Awel y Môr Offshore Wind Farm

Application Errata List (Clean)

Deadline 8

Document Reference: 8.39

FIGURE NUMBER:
Figure 19

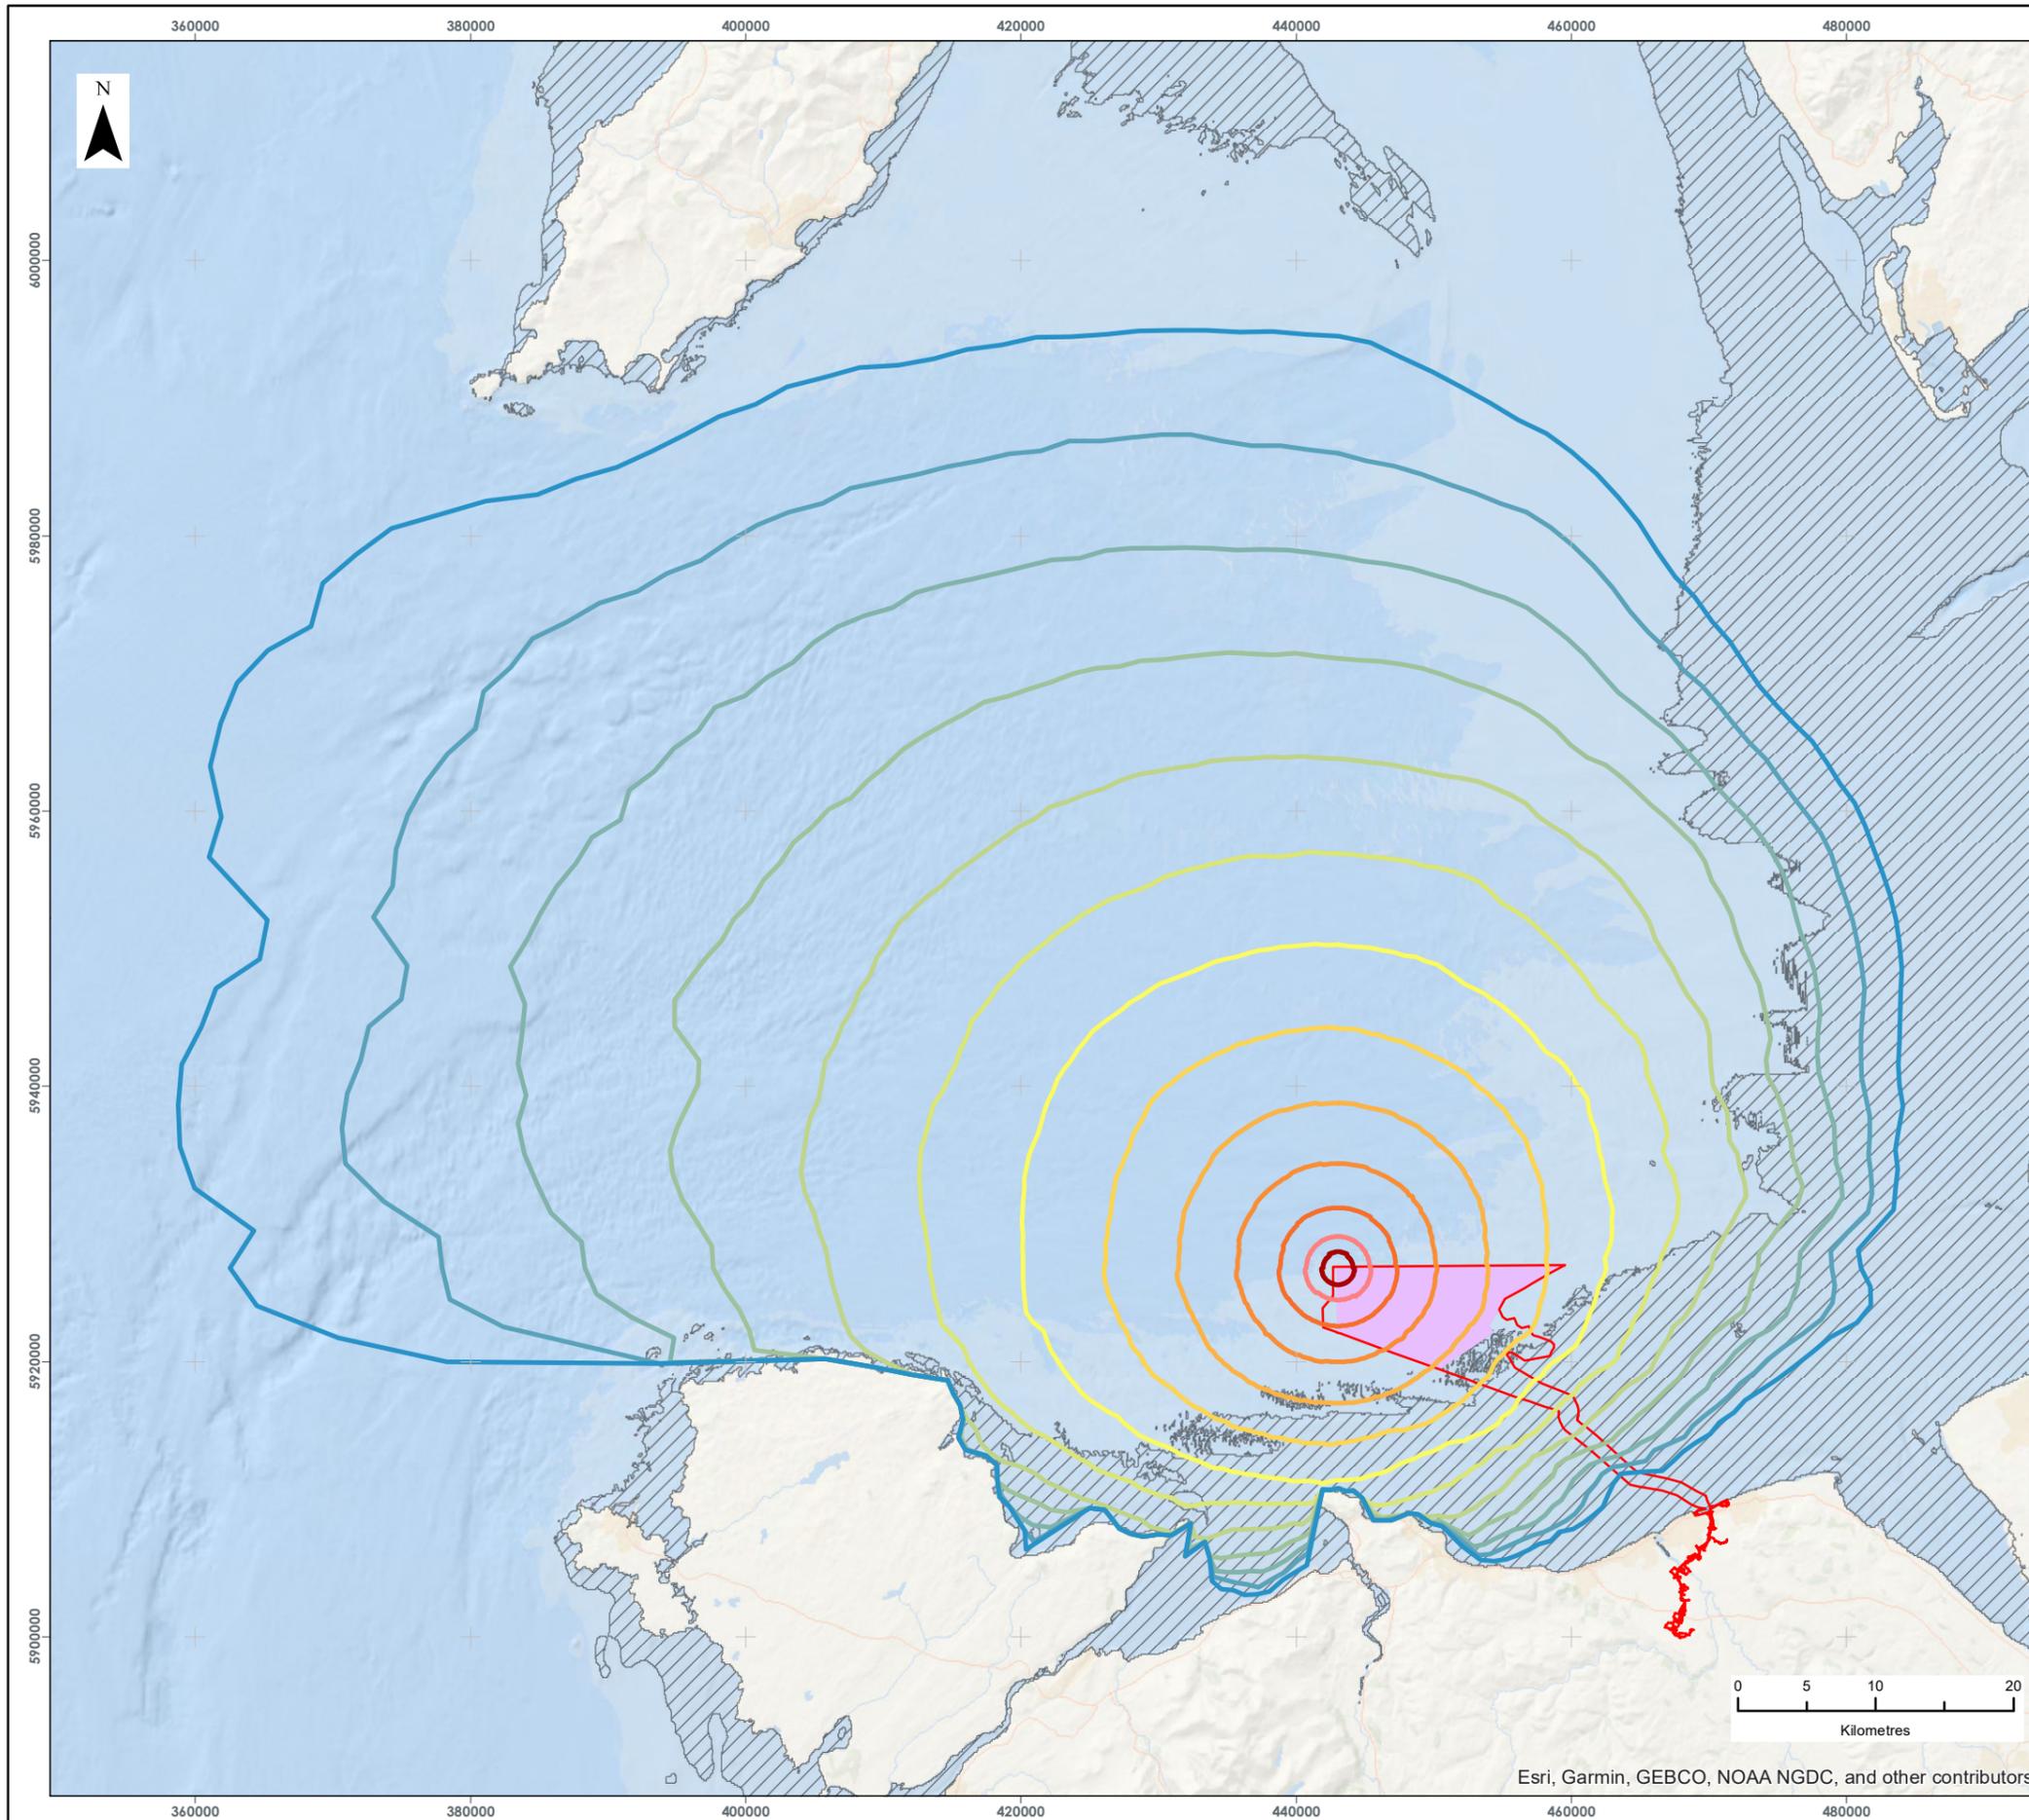
- ▲ Figure 19: Figure missing from AS-026 with Figure 21 incorrectly presented in its place. Corrected figure provided in Appendix A of this document. Note this figure is identical to Figure 19 presented in APP-053.

FIGURE NUMBER:
Figure 21

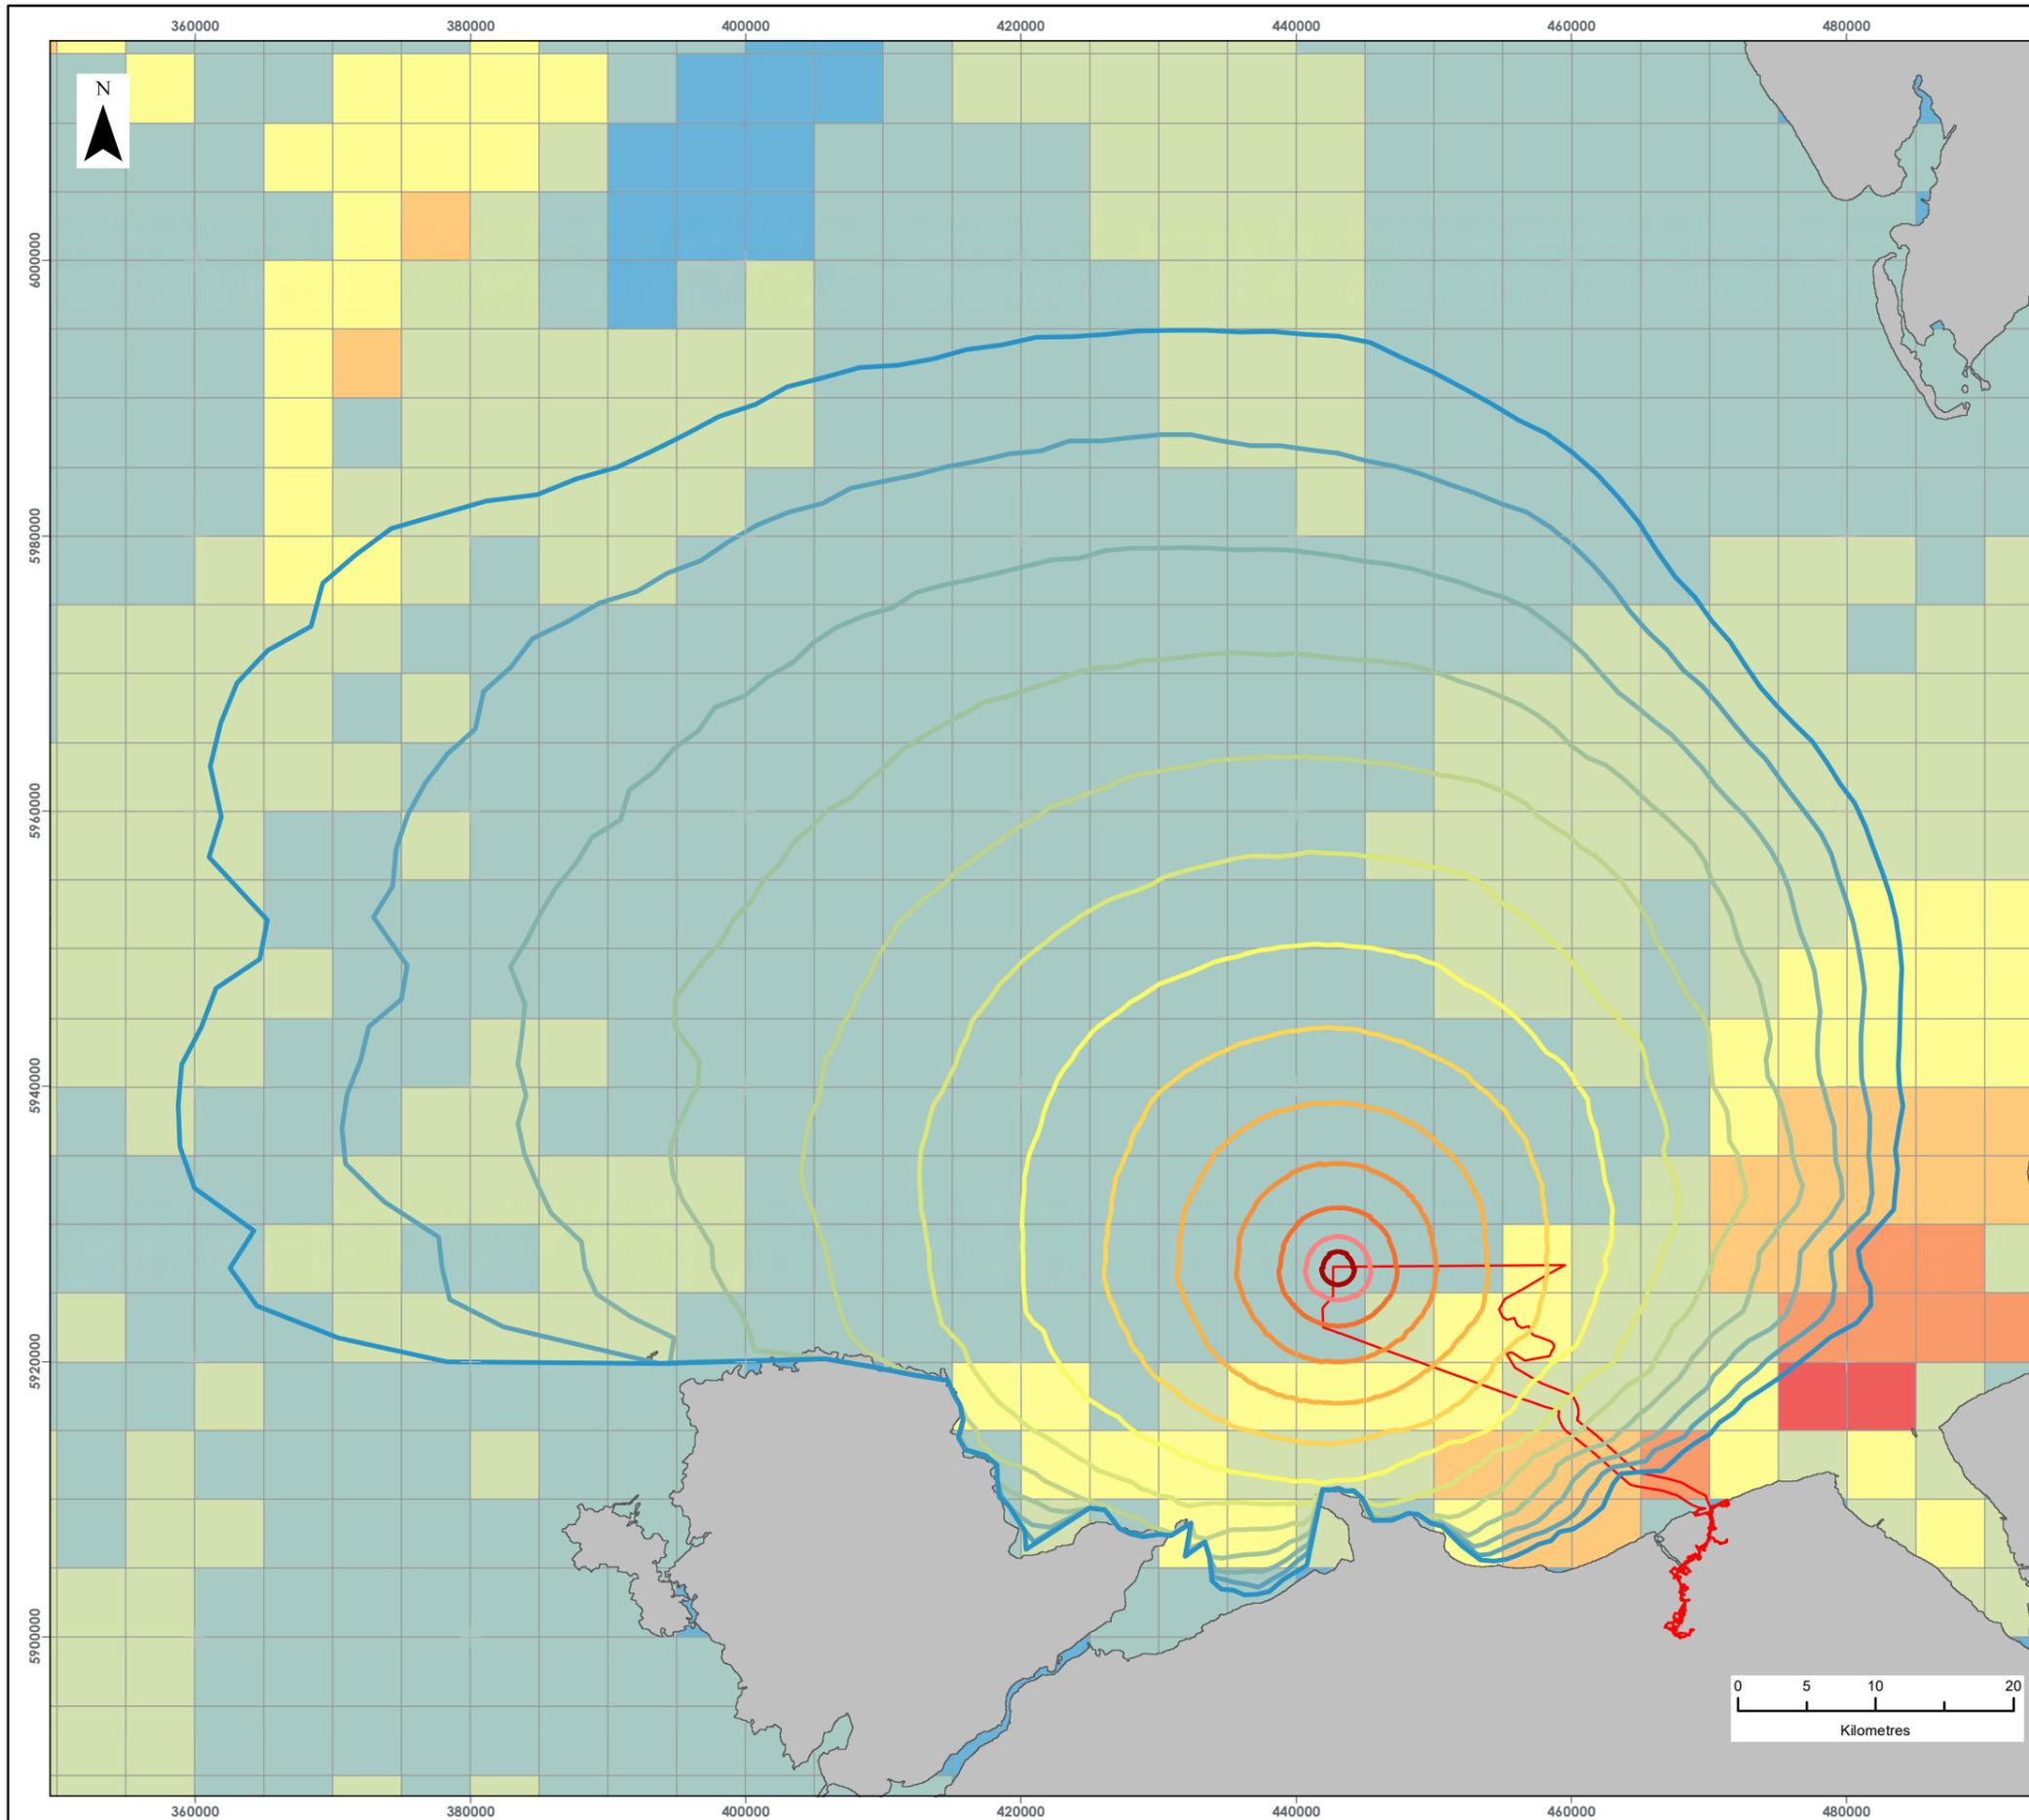
- ▲ Figure 21: Figure incorrectly displayed a partial black background and omitted base mapping. Figure was incorrectly presented in place of Figure 18. Corrected figure provided in Appendix A of this document. Note this figure is identical to Figure 21 presented in APP-053.
